Burst CRC and FEC block CRC for 16m uplink and downlink data channel

IEEE C802.16m-08/1386

Re : TGM SDD: Other (Reply to Call for comments (IEEE 80216m-08/040) on SDD (IEEE 80216m-08/003r5)

To discuss and adopt the proposed text in the revision of the 802.16m SDD

Figure 43 Channel coding block diagram

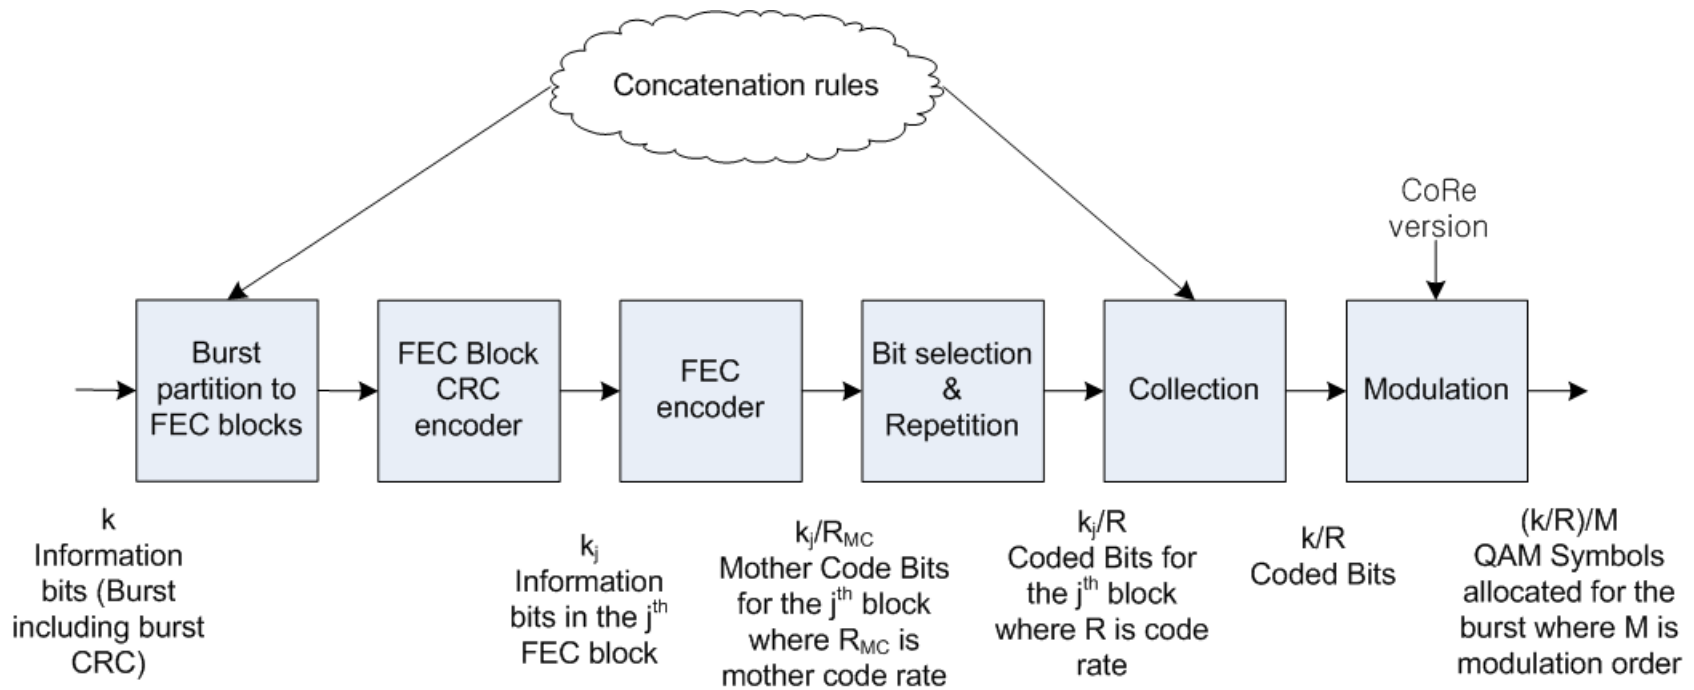
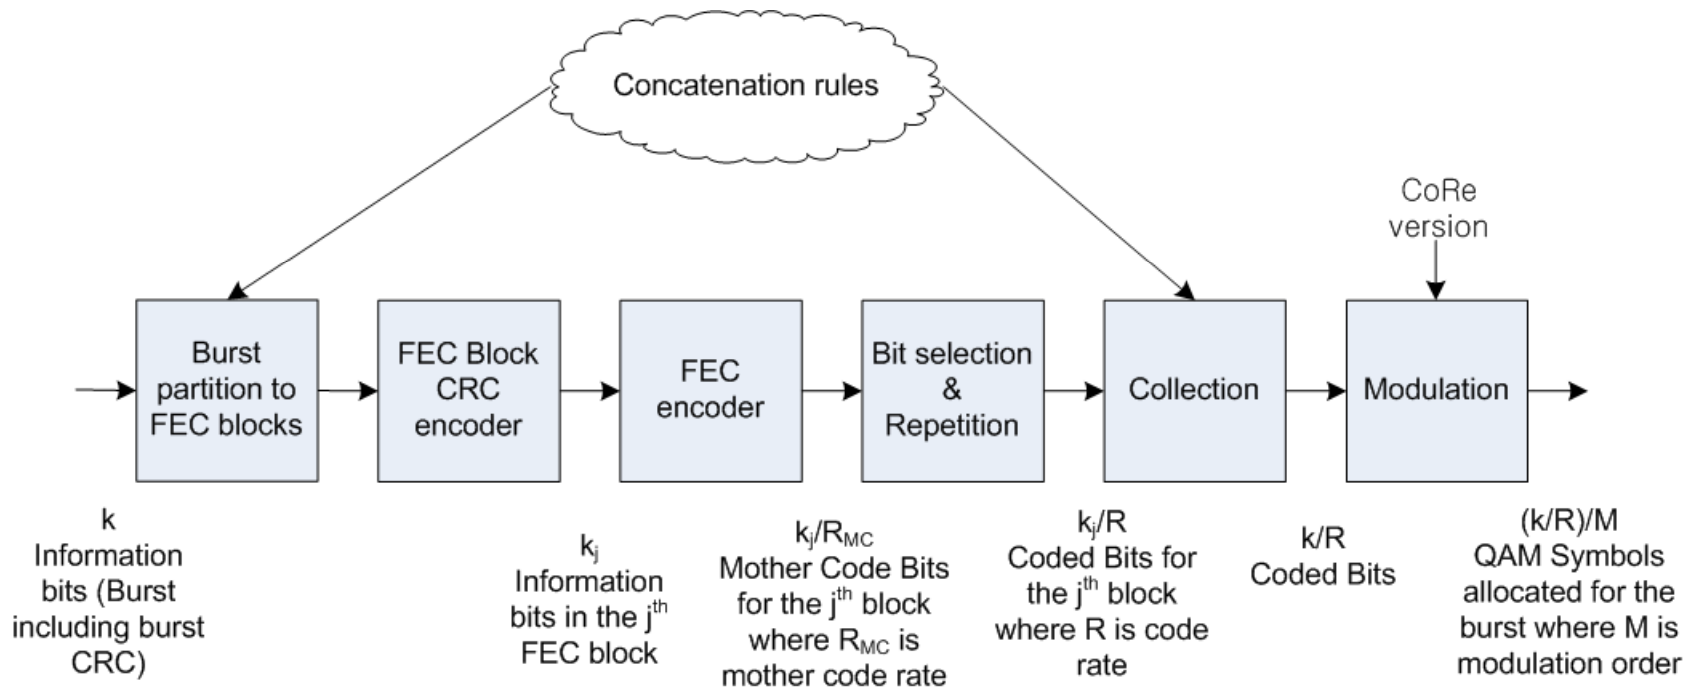
- Page 102, line 15,
 - Replace current block diagram by following figure;

- Page 102, line 15,
 - Replace current figure by following;
- Page 102, at the beginning of line 18,
 - Add “A 24-bit burst CRC is appended to a burst before the burst is further processed by burst partition. The generator polynomial of the burst CRC is $g_{\text{burst}}(x) = x^{24} + x^{23} + x^{18} + x^{17} + x^{14} + x^{11} + x^{10} + x^7 + x^6 + x^5 + x^4 + x^3 + x + 1$. The burst CRC is calculated based on all the bits in the burst.”

- Page 102, line 19, between “... is encoded separately.” and “The maximum FEC block ...”
 - Insert “If a burst is partitioned into more than one FEC blocks, a 16-bit FEC block CRC is appended to each FEC block before the FEC encoding. The generator polynomial of the FEC block CRC is $g_{\text{block}}(x) = x^{16} + x^{12} + x^5 + 1$. The FEC block CRC of an FEC block is calculated based on all the bits in that FEC block.”

- Page 102, line 21-22,
 - Delete the sentence “Error detection is provided at the end of the burst by appending a Cyclic Redundancy Check (CRC).”

- 11.13.1.2 Partition into FEC blocks
 - A 24-bit burst CRC is appended to a burst before the burst is further processed by burst partition. The generator polynomial of the burst CRC is $g_{\text{burst}}(x) = x^{24} + x^{23} + x^{18} + x^{17} + x^{14} + x^{11} + x^{10} + x^7 + x^6 + x^5 + x^4 + x^3 + x + 1$. The burst CRC is calculated based on all the bits in the burst. When the burst size exceeds the maximum FEC block size, the burst is partitioned into a number of smaller blocks, each of which is encoded separately. If a burst is partitioned into more than one FEC blocks, a 16-bit FEC block CRC is appended to each FEC block before the FEC encoding. The generator polynomial of the FEC block CRC is $g_{\text{block}}(x) = x^{16} + x^{12} + x^5 + 1$. The FEC block CRC of an FEC block is calculated based on all the bits in that FEC block. The maximum FEC block size is TBD. Concatenation rules are based on the number of information bits and do not depend on the structure of the resource allocation (number of LRUs and their size). The concatenation rules are FFS. ~~Error detection is provided at the end of the burst by appending a Cyclic Redundancy Check (CRC).~~
